Re: *Project No. 35077; Informational Filing of ERCOT Interconnection Agreements  
Pursuant to Subst. R. § 25.195(e)*

**FIRST AMENDMENT TO  
INTERCONNECTION AGREEMENT**

This First Amendment is made and entered into this 1st day of June, 2021 between **Lone Star Transmission, LLC** (“Transmission Service Provider”) and **Ranchland Wind Project, LLC** (“Generator”), hereinafter individually referred to as “Party,” and collectively referred to as “Parties.”

**Exhibit “C”  
Interconnection Details**

# **Attachment C-1** **Conceptual Drawing of Point of Interconnection**

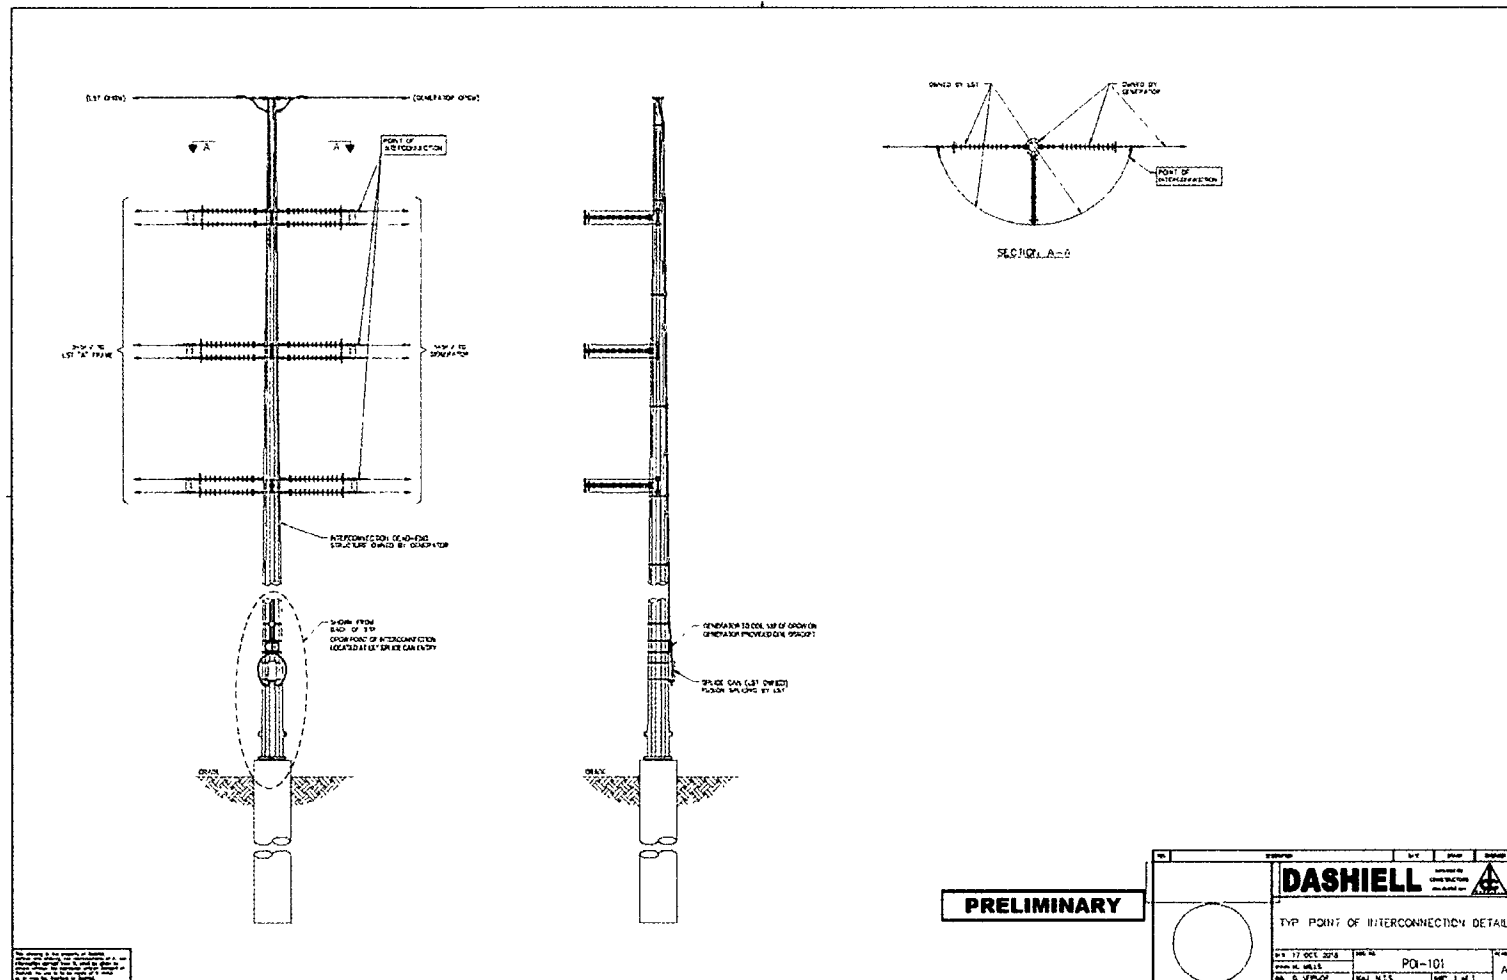
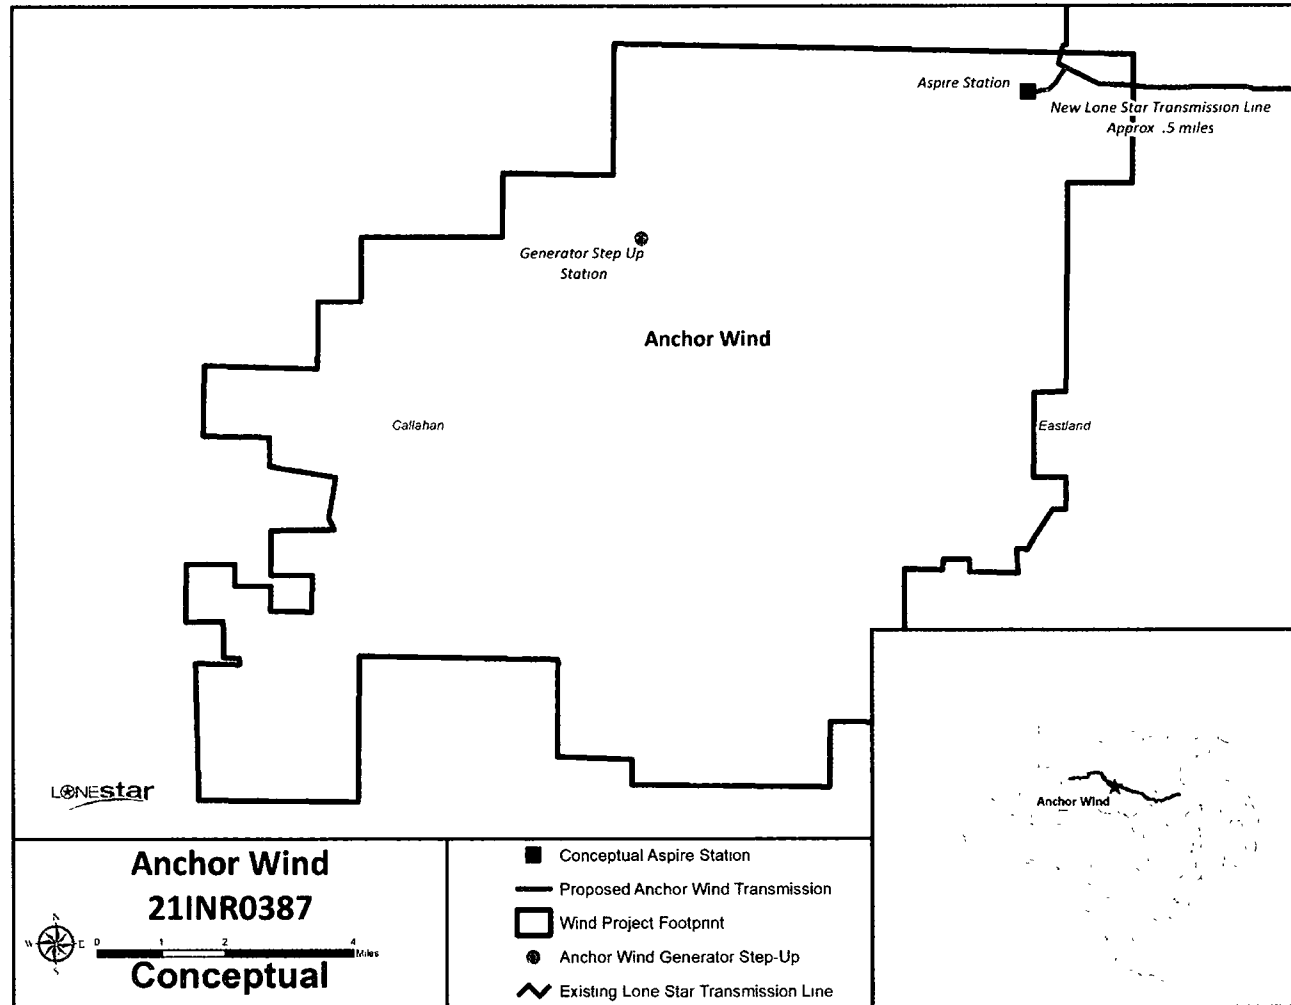
- 1     Name: Anchor Wind Project
- 2     Point of Interconnection (POI) Location: The POI between the GIF and TIF will be located at a new Generator owned dead-end structure at the end of the Customer’s new 345 kV generation tie line located outside of the new TSP Aspire Station (shown on Attachment “C-1” and “C-2”). The POI shall be the physical point where the TSP facilities are connected to the GIF. This point is more specifically defined as being located at the 4-hole pad terminals on the insulator hardware at the dead-end structure where the TSP’s 345 kV transmission line connects to Generator Slack span connection to the GIF.
